NOAA FORM 77-28 (11-72)	U.S. DEPARTMENT OF COMMERCE NATIONAL OCEANIC AND ATMOSPHERIC ADMINISTRATION	REGISTRY NO.  <h1 style="margin: 0;">H12096</h1>
<h2 style="margin: 0;">HYDROGRAPHIC TITLE SHEET</h2>		
<b>INSTRUCTIONS</b> - The Hydrographic Sheet should be accompanied by this form, filled in as completely as possible, when the sheet is forwarded to the Office.		FIELD NO. <h1 style="margin: 0;">B</h1>

Sub-Locality Southern Brunswick Safety Fairway

Verification by Atlantic Hydrographic Branch  
**Bold, Italic, Red notes were made during office processing**

**Descriptive Report to Accompany  
Hydrographic Survey H12096  
Scale 1:20,000, Surveyed 2010  
*M/V Atlantic Surveyor*  
Science Applications International Corporation (SAIC)  
Evan J. Robertson, Lead Hydrographer**

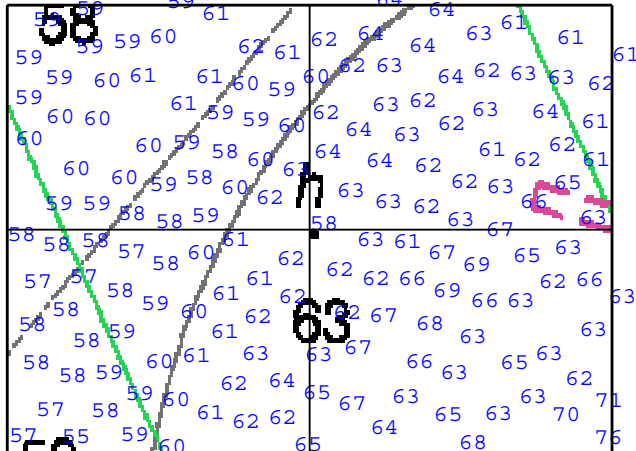
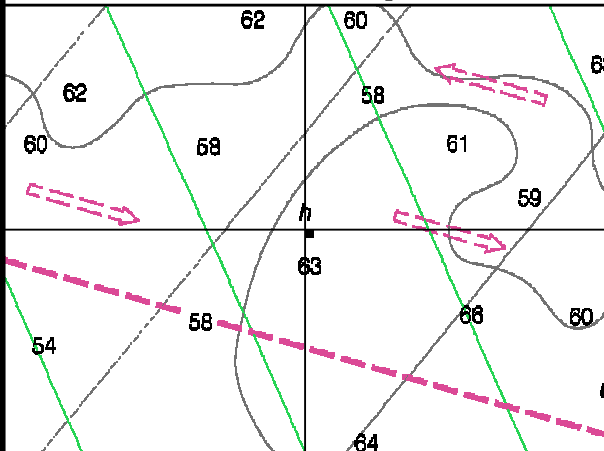
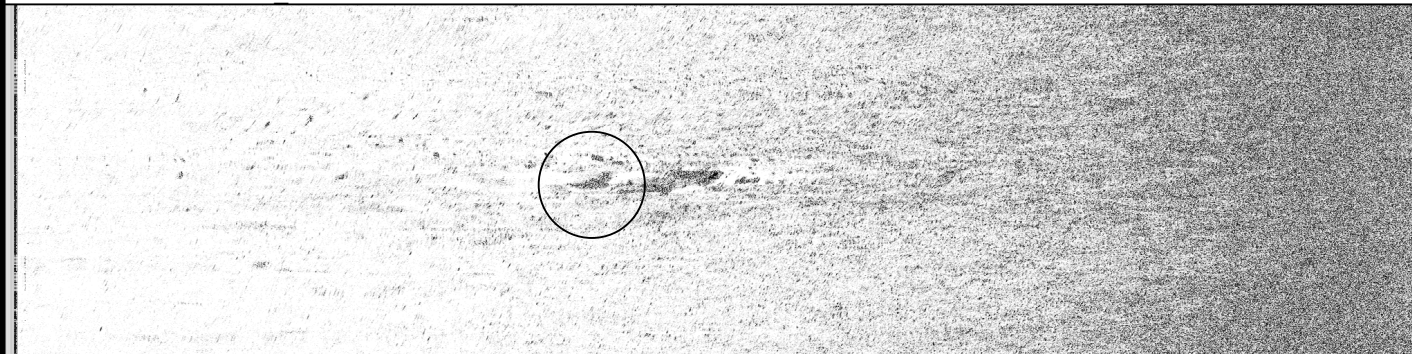
COMMENT:  
OBSTRS. No chart.  
Nonsignificant relative to  
surrounding natural depths.  
Located within fairway.

**Concur with clarification. Least  
depth of feature is not significant  
relative to surrounding depths.  
Chart as 58 ft Sounding.**

Feature #: 0002 Least Depth: 55(ft), 16.82(m) Lat: 30 55 18.46N Lon: 080 58 36.24W Ping: 3332 Beam: 230

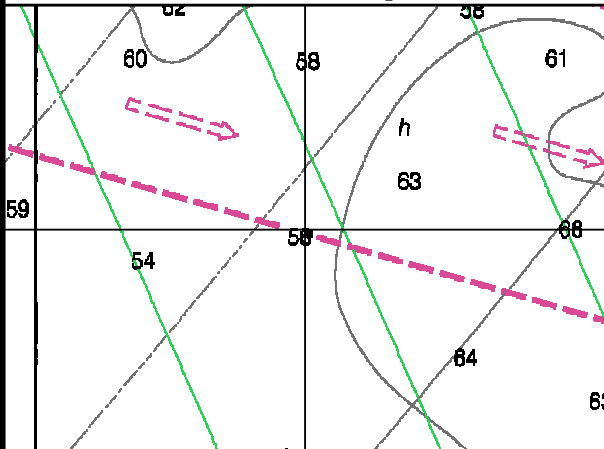
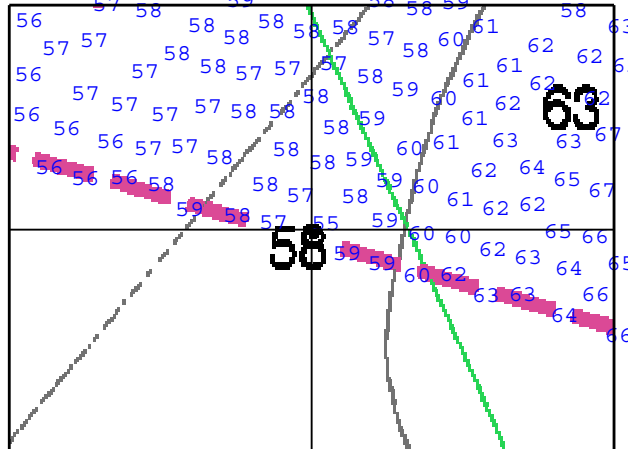
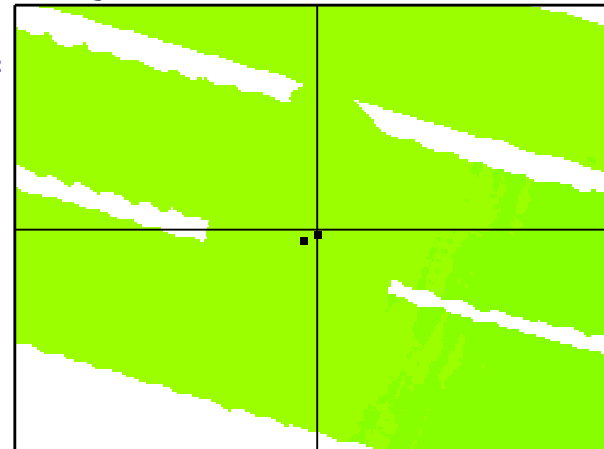
COMMENT:  
OBSTR. Chart sounding and  
danger circle and label  
'Obstn'. Located within  
fairway.

**Concur with clarification. Least  
depth of feature is not significant  
relative to surrounding depths.  
Chart as 55 ft Sounding.**

Feature #: 0003 Least Depth: 46(ft), 14.03(m) Lat: 30 57 16.15N Lon: 081 05 24.17W Ping: 3107 Beam: 234

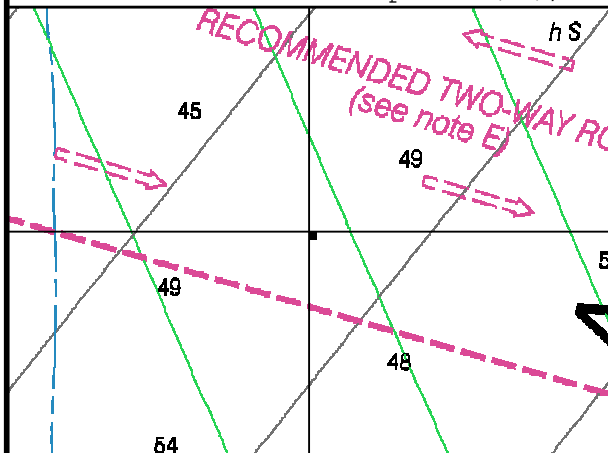
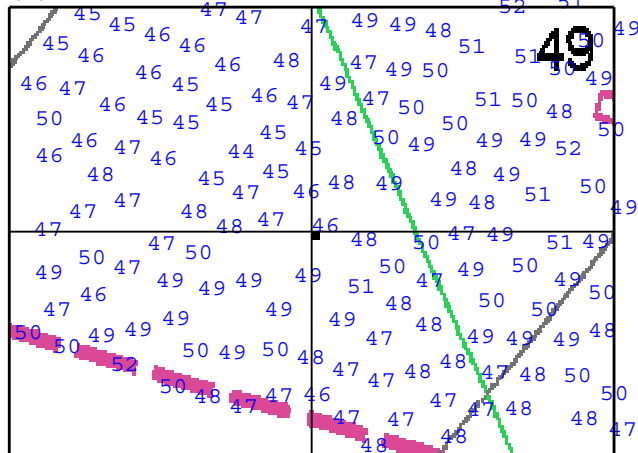
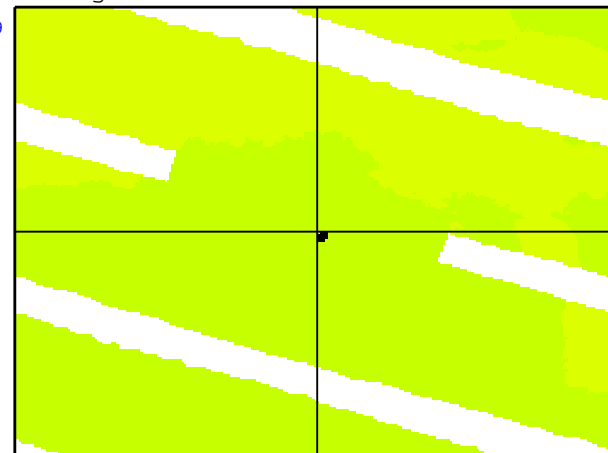
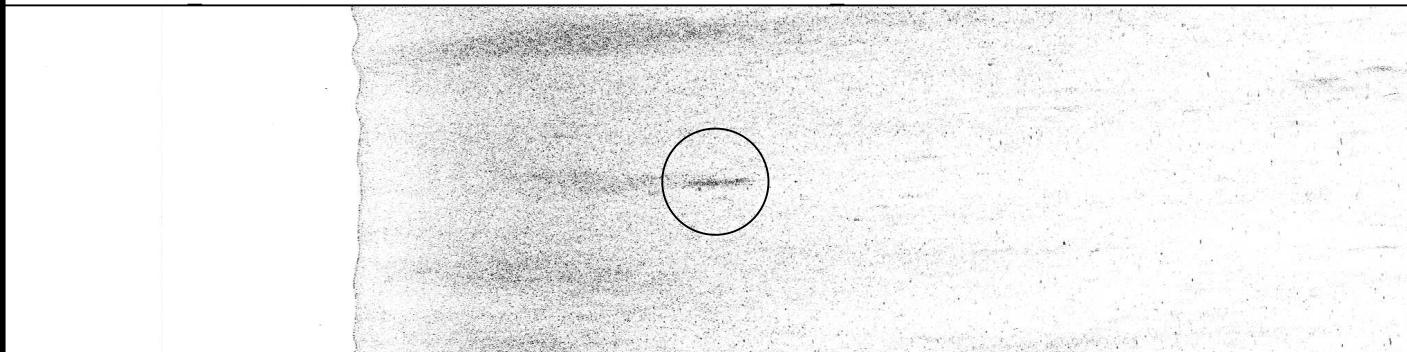
COMMENT:  
OBSTR. No chart.  
Nonsignificant relative to  
surrounding natural depths.  
Located within fairway.

**Concur with clarification. Least  
depth of feature is not significant  
relative to surrounding depths.  
Do not chart.**
